# CITY OF ALBUQUERQUE

**RE: 4605 Albany NE**  
**Grading Plan**  
**Stamp Date: 9/27/17**  
**Hydrology File: B12D014**

Based upon the information provided in your submittal received 09/27/2017, the Grading Plan **is not** approved for Building Permit and Grading Permit. The following comments need to be addressed for approval of the above referenced project:

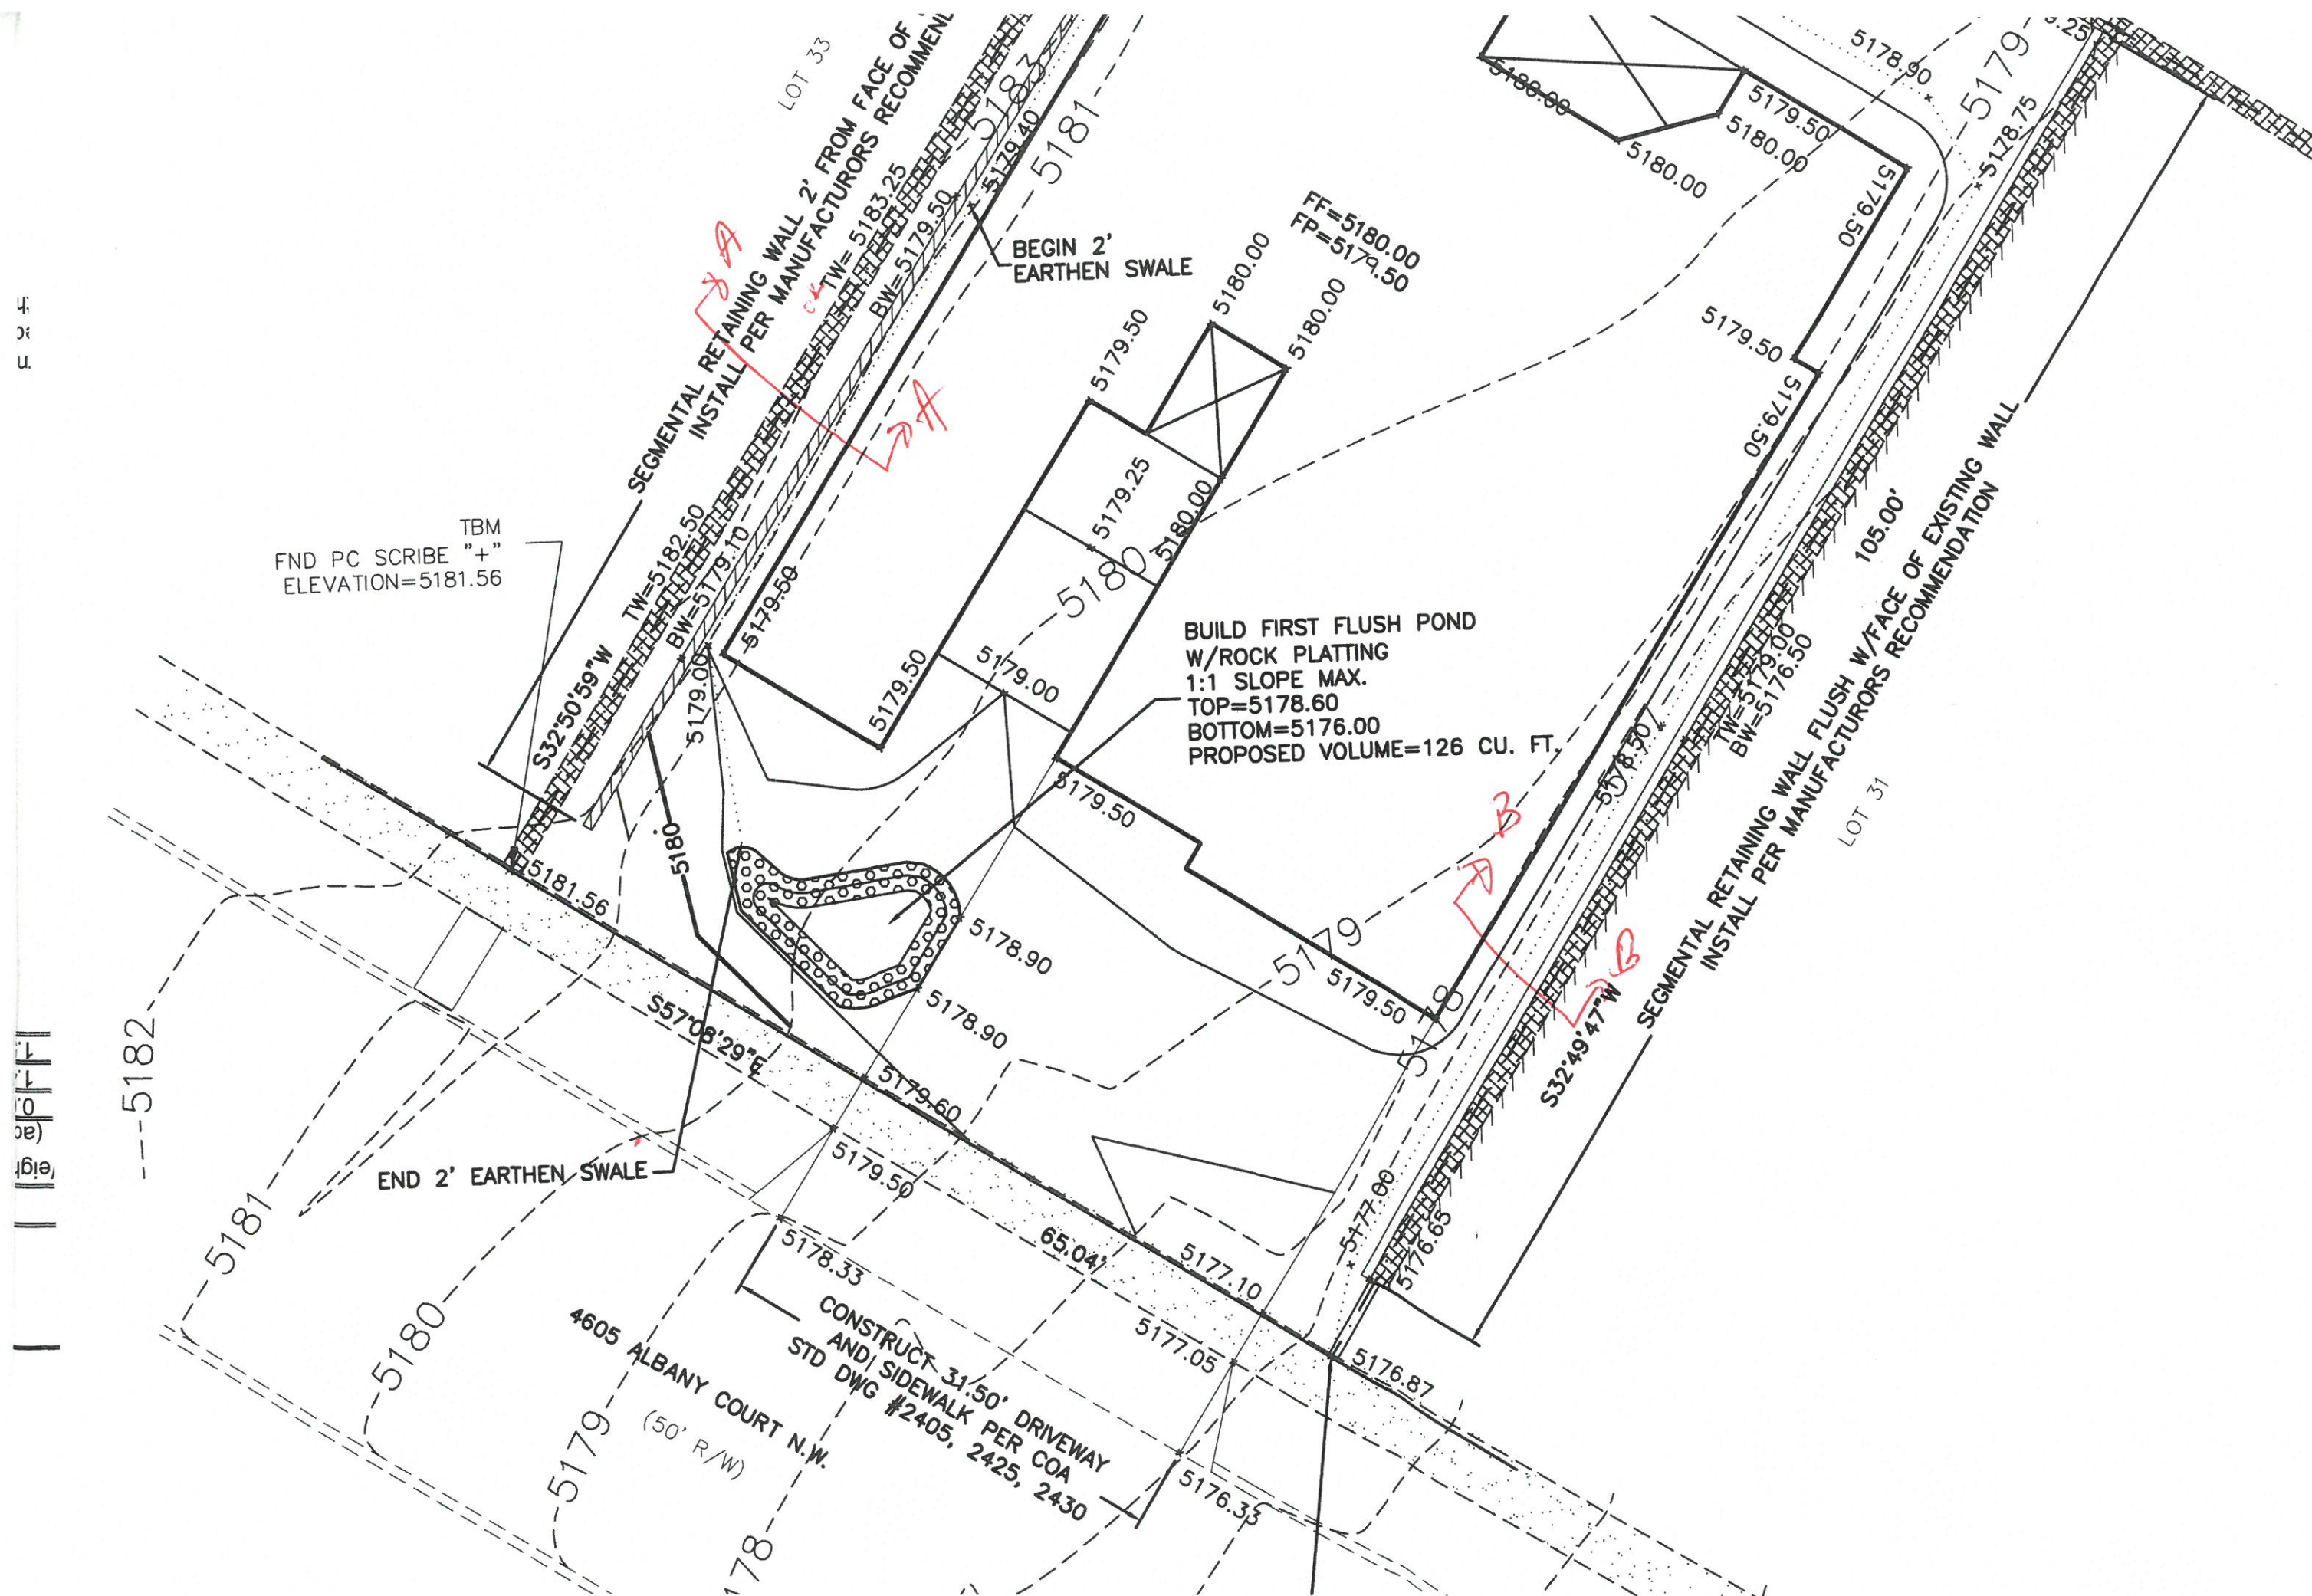
1. Please provide a cross section for both proposed retaining walls. Please include the existing retaining wall, the property line, and footer information. I'm epically concerned about the East wall since you are putting this flush with the existing wall. I want to ensure the integrity of the existing retaining walls. See Attached sheet for the location of the cross sections in question.
